ADDENDUM NO. 1

CONTRACT NO. 43-14-08

BRIDGE DECK REPAIR AND REHABILITATION
OHIO TURNPIKE OVER NORFOLK SOUTHERN RAILROAD M.P. 147.9
LORAIN COUNTY, OHIO

MODIFICATIONS TO THE CONTRACT DOCUMENTS
PLAN DRAWING SHEET 7 OF 12

PROJECT 43-14-08 SHEET 7 OF 12

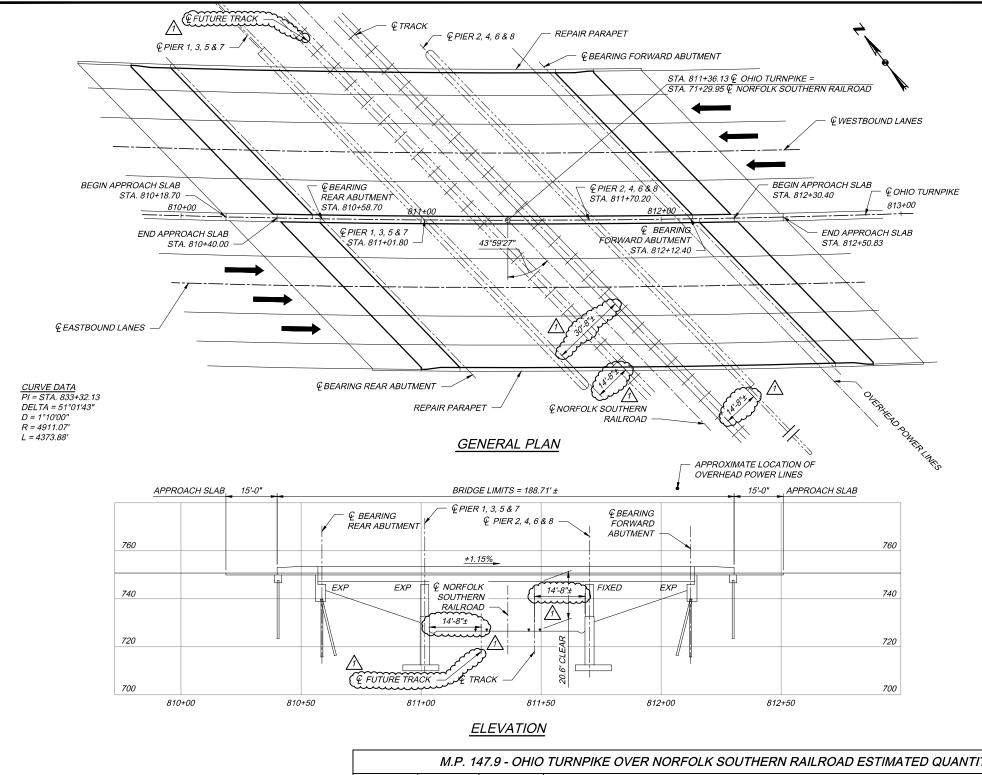
a cloud and revision triangle thus:
The following plan sheet has been updated and the new plan sheet should be substituted for: - Sheet number 7 of 12.
Modifications to the Special Provisions Deletions in are shown with strikethrough text. Changes/Additions are shown with bold italicized text.
The following Special Provision sheet has been updated and the sheet should be substituted for: - Page SP-83
Addendum No. 1 to Contract No. 43-14-08 is hereby acknowledged:
(Firm Name)
(Signature)
(Printed Name)
Date:

EXISTING = 20.6' REQUIRED = 20.6' **HORIZONTAI**

EXISTING = 14'-8" REQUIRED = 13'-0"
